# Access Compliance Report

## Public Rights-of-Way

### (Curb Ramps)

Intersection ID: 52100	Main Street: FRED_D_ALEXANDER_BV	Cross Street: FREEDOM_DR	Location: SW
ADA ID: 3E672573AFCA	Ramp Type: Perp	Initial Pass/Fail: Fail	Overall Compliance: No
Codes/Mitigation Info/Possible Solution		Field Measurements/Component Compliance	
Severity Score: 10

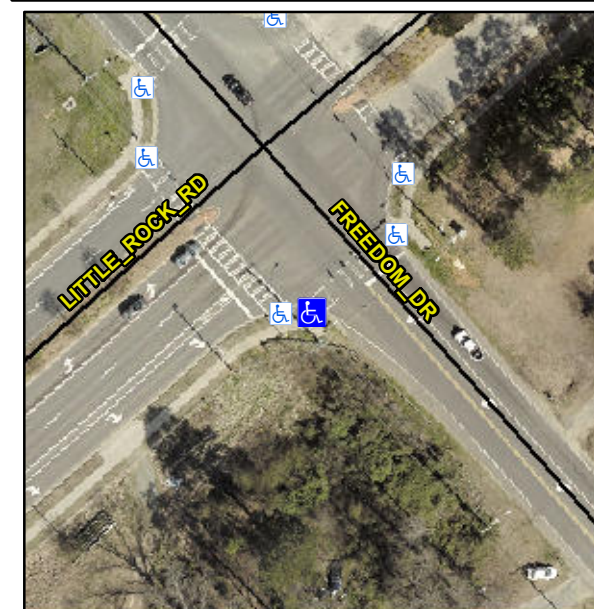
**R304.5.1, R304.5.3**

Compliance	Description	Data	Compliance	Description	Data
N/A	Ramp Length (in)	124.5	Yes	Ramp Slope (%)	6.7
No	Ramp Width (in)	47.0	No	Ramp XSlope (%)	2.8
N/A	Flare Type LT	N/A	N/A	Flare Type RT	N/A
N/A	Flare Slope LT (%)	N/A	N/A	Flare Slope RT (%)	N/A
N/A	Flare Traversable LT?	N/A	N/A	Flare Traversable RT?	N/A
N/A	Landing Length (in)	N/A	N/A	DWS Provided?	N/A
N/A	Landing Width (in)	N/A	N/A	DWS Contrast?	N/A
N/A	Landing Slope (%)	N/A	N/A	DWS Length (in)	N/A
N/A	Landing X Slope (%)	N/A	N/A	DWS Full Width?	N/A
N/A	Landing Curb? (Y/N)	N/A	N/A	DWS Offset (in)	N/A
N/A	Shared Landing?	N/A			
N/A	Gutter Ponding?	N/A	N/A	Gutter Slope (%)	N/A
N/A	Gutter Lip Ht (in)	N/A	N/A	Gutter X Slope (%)	N/A
N/A	Painted X Walk1?	Yes	N/A	Painted X Walk2?	N/A
	X Walk 1 Direction	To NE		X Walk 2 Direction	N/A
N/A	X Walk 1 Width (in)	113.0	N/A	X Walk 2 Width (in)	N/A
	X Walk 1 Slope (%)	3.8		X Walk 2 Slope (%)	N/A
	X Walk 1 X Slope (%)	1.3		X Walk 2 X Slope (%)	N/A

**Remove & Replace Entire Ramp.**
